Subject: **FIELD SAFETY NOTICE - RECALL LETTER**
 Medical device: **Drilling guide for diameter 3.5 mm screw**
 Reference: **219 635**
 Legal manufacturer: **Newdeal SAS - 97 allée Alexandre Borodine 69800 Saint Priest – France.**
 Batches involved: **E1DT-E4EX-E57T-E5YA-E64W-E6GN-E6RB-E6WP-E7UL-E86B-E8UC-E9PX-E9Q5-E9QD-EBNY-EEYJ-EF11-EFCM-EGT6-EH6X-EHL2-EJB3-EJZE-EKJ4-EKN4-EKZV-EKZW-EL3G-EL3X-ELH8-EMCQ-EMCX-EN19-ENR9-ENRA-ENS0-EPTL.**

INSPECTION SHEET
 Identification of the old version of **drilling guide for diameter 3.5 mm screw** -
 Reference: **219 635**
 To be removed and shipped back to NEWDEAL S.A.S.
ONLY THE OLD VERSION IS TO BE RETURNED.

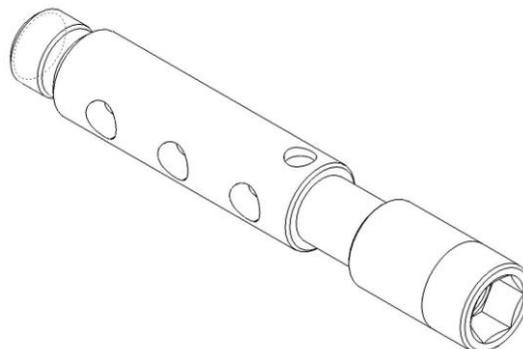
STEP 2: - Assess the device’s version (old or new version) as indicated by the pictures below:

OLD VERSION

NEW VERSION

STEP 3: -If the old version is identified: please complete the “Recall acknowledgment and Return Form” and follow the instructions for product return:
 -If the new version is identified: keep the device.
